TOWN OF MILFORD, NH
OFFICE OF COMMUNITY DEVELOPMENT

Date: August 10, 2022
To: Planning Board
From: Camille Pattison, NRPC Assistant Director
Subject: SP2022-08 Sooner Transportation LLC, for the property located at Tax Map 12, Lot 11, 754-756 Elm Street (Horseless Carriage Site). Public Hearing for a Major Site Plan Application to construct a two-story, 10,320 sf. auto sales and repair facility with associated parking, stormwater management/drainage, landscaping, and lighting improvements on the subject property located in the Commercial 'C' Zoning District and West Elm Overlay District.

**Re: Sooner Milford Site Plan (Tax Map 12, Lot 11) – 754 and 756 Elm Street
Site Plan Drainage Review**

SOONER MILFORD SITE PLAN

TAX MAP 12 LOT 11
OVERVIEW & SITE PLAN
SOONER-MILFORD
LOCATED AT:
754-756 ELM STREET
MILFORD, NEW HAMPSHIRE, 03055

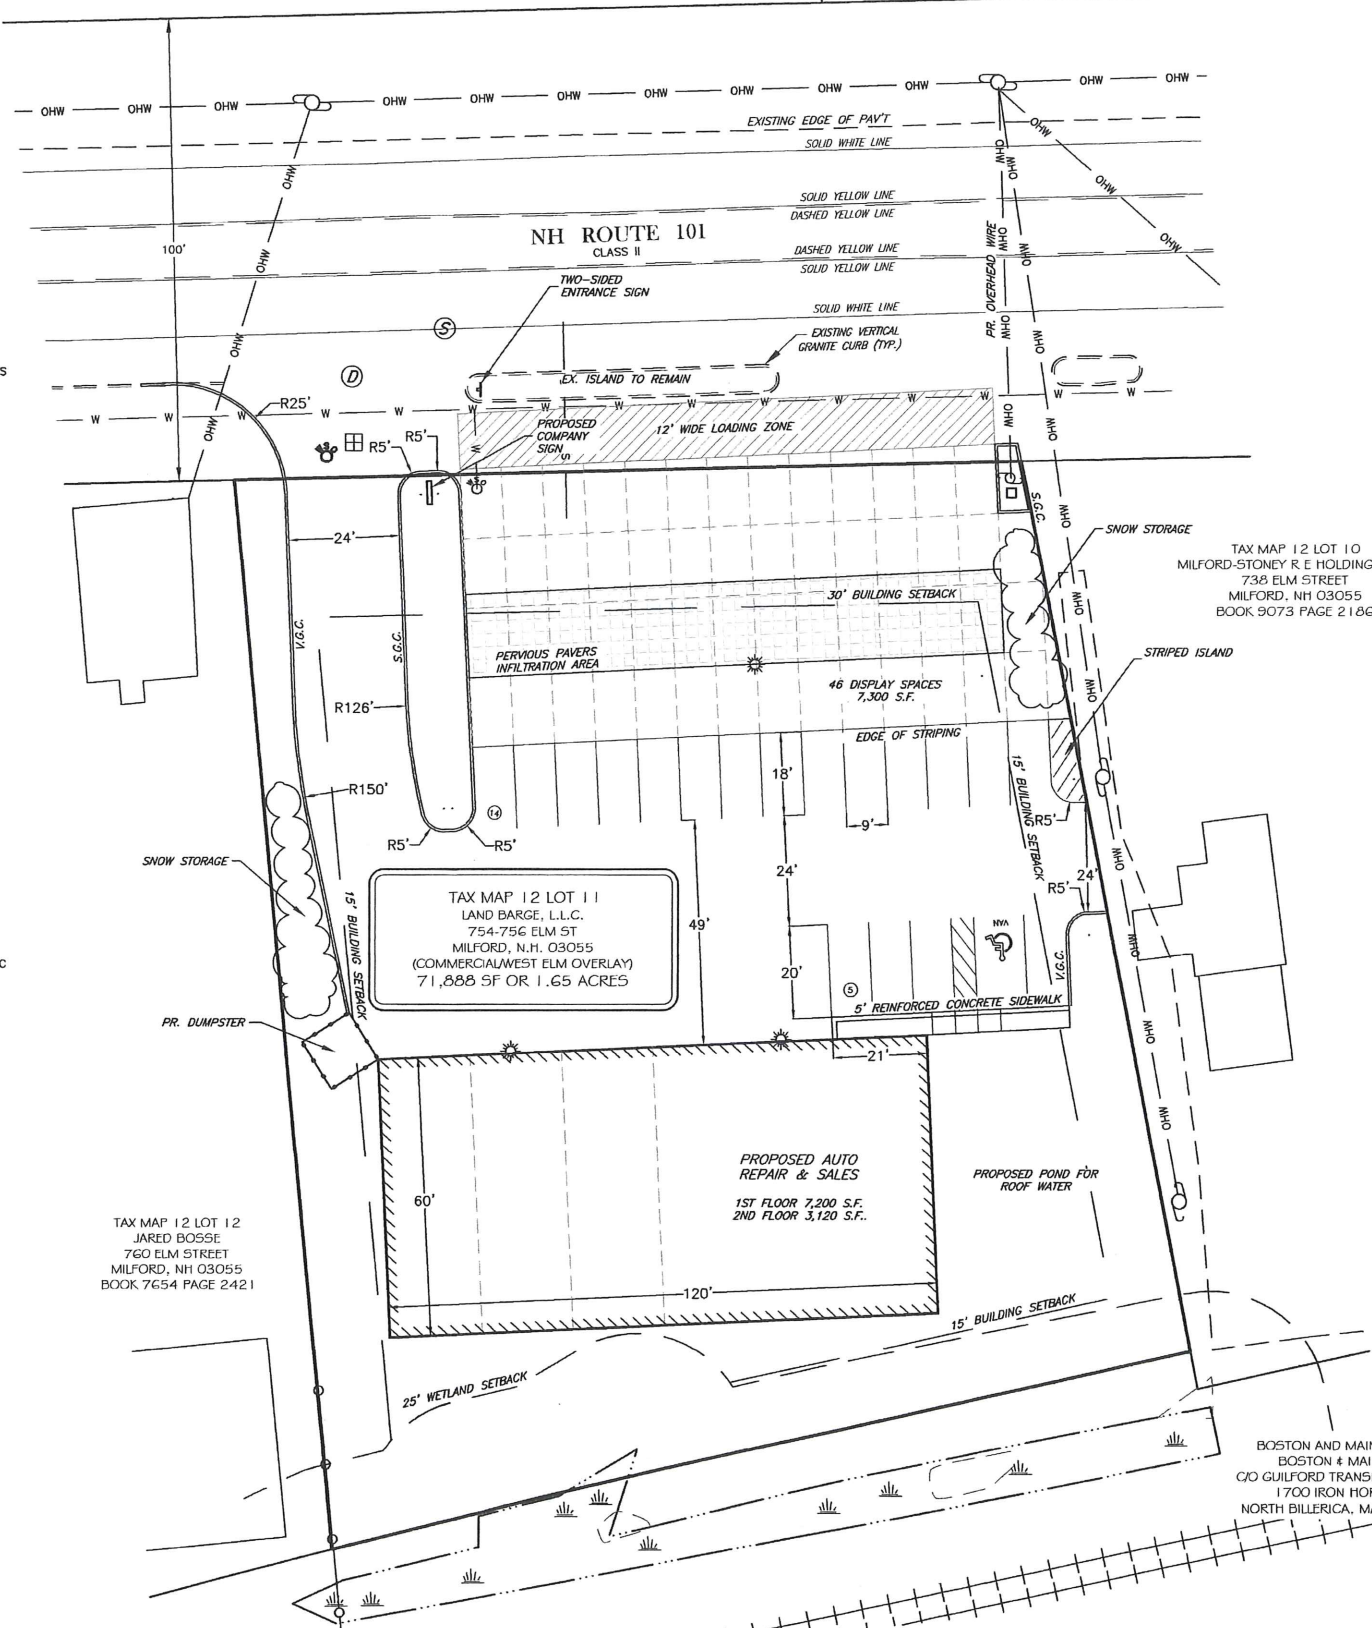
8. Sheet 1, Note 8 – Please update the site plan to include the existing and resulting open space calculations in the *Dimensional Regulations: Commercial* table.

11. Sheet 1 – The plan displays a 12’ wide loading area within the state owned right of way. The proposal may effect and impact the traffic conditions on Elm Street and abutting properties. Further as stated in Section 6.05.6.E, all off-street parking and loading or unloading spaces shall be at least ten feet (10’) from any public street right-of-way and shall be separated from such right-of-way by a granite curb and landscaping as required in 6.08 LANDSCAPING STANDARDS. The proposal require a waiver of these requirements and require NHDOT approval and dedicated easement to use the area within the right of way.

12. Sheet 1 – The plan shows display parking space partially located off the property and within the State right-of-way. As stated in the Zoning Ordinance, Section 6.05.6.E, Parking and loading spaces shall be arranged so that cars will not back into public roads. The plan will need to amended to relocate said parking spaces within the subject property at least 10 feet from the Elm Street public right-of-way.

13. Sheet 1 - The applicant should be explain the internal circulation, access/egress patterns for the 46+ display vehicles. At a minimum, the plan should be revised to include the appropriate isle widths between the rows of display vehicle parking.

14. Sheet 1 – Staff questions if the adequate snow storage areas have been provided. A note should be added to the plan stating that snow shall be removed to an offsite location using best management practices.

DETAIL SHEET 3
SOONER-MILFORD
 LOCATED AT:
754-756 ELM STREET
MILFORD, NEW HAMPSHIRE, 03055

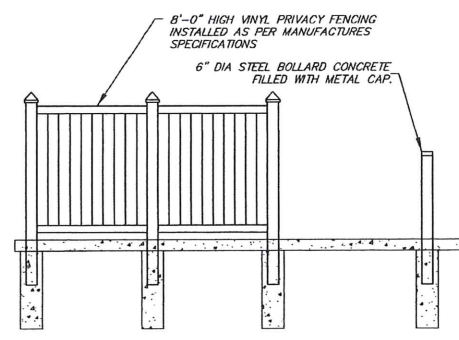
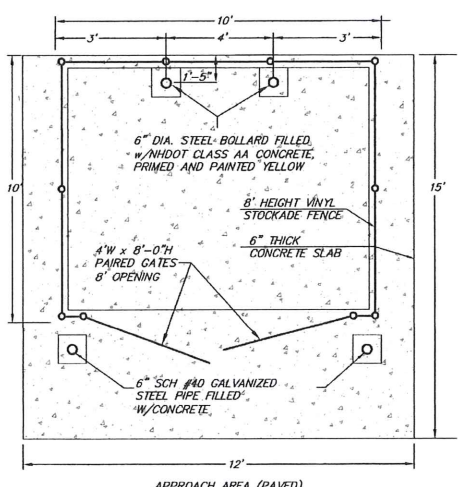
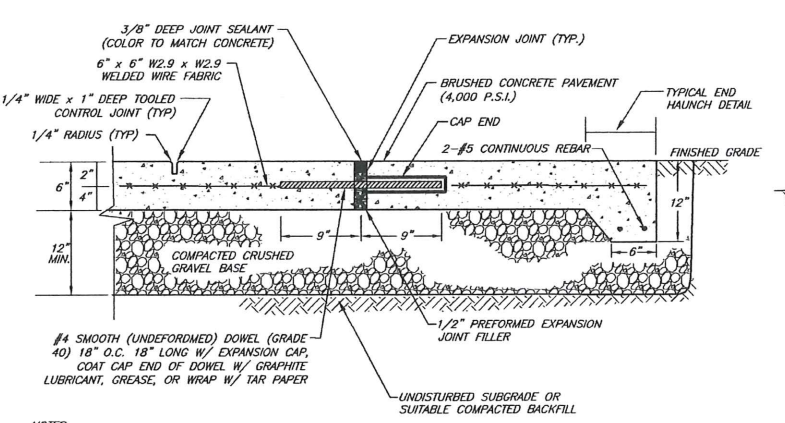
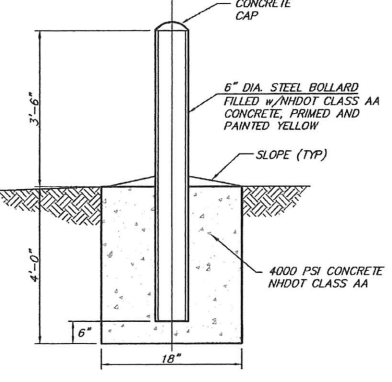
9. Please revise site plan to include all proposed signage for the project.
10. Sheets 1 and 10 – The site plan shows the proposed location of the dumpster and pad encircled by an 8’ stockade fence within the 15 foot westerly side dimensional setback. The proposed 8’ stockade fence and concrete pad are defined as structures in the Town’s Zoning Ordinance and such, would require a Special Exception by the Board of Adjustment for relief of this requirement. The alternative would be amend the plan and relocate the dumpster outside of the dimensional setback.
